TECHNICAL SERVICE BULLETIN

Luggage Compartment Scuff Plate To Luggage Compartment Side Trim Panel Gap

24-2422

Ford 2024 Mustang

Figure 3

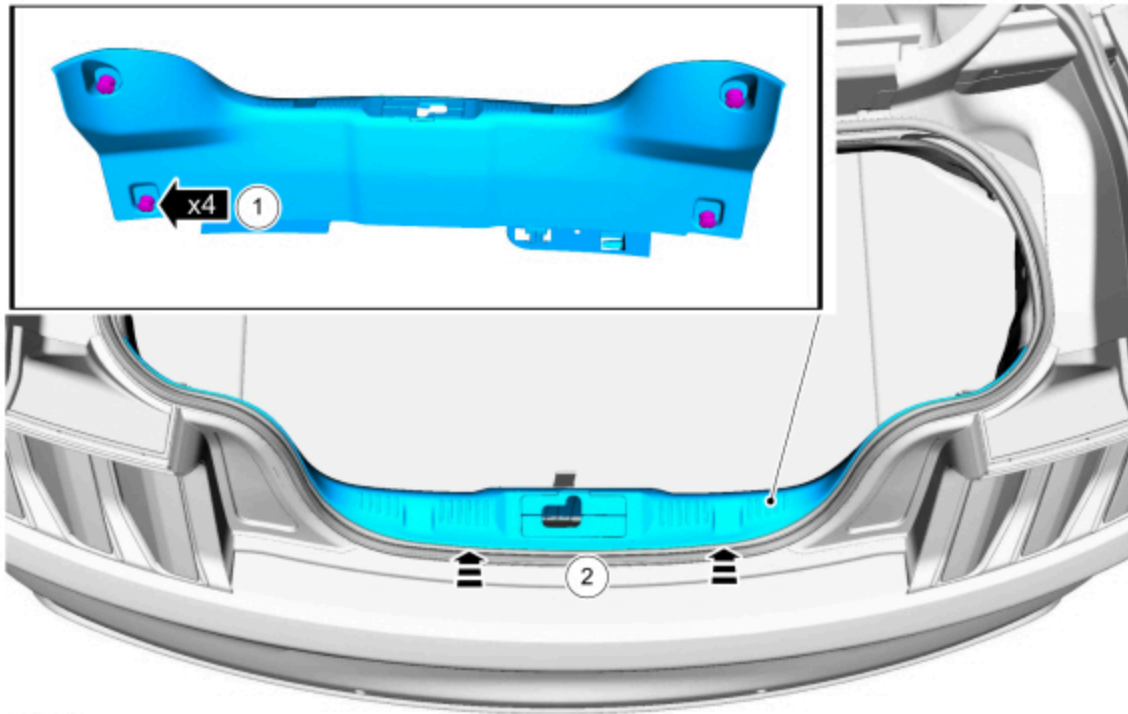
2. Remove the luggage compartment scuff plate by unscrewing the thumb nut type retainers. (Figure 3)

3. Install the new luggage compartment scuff plate.
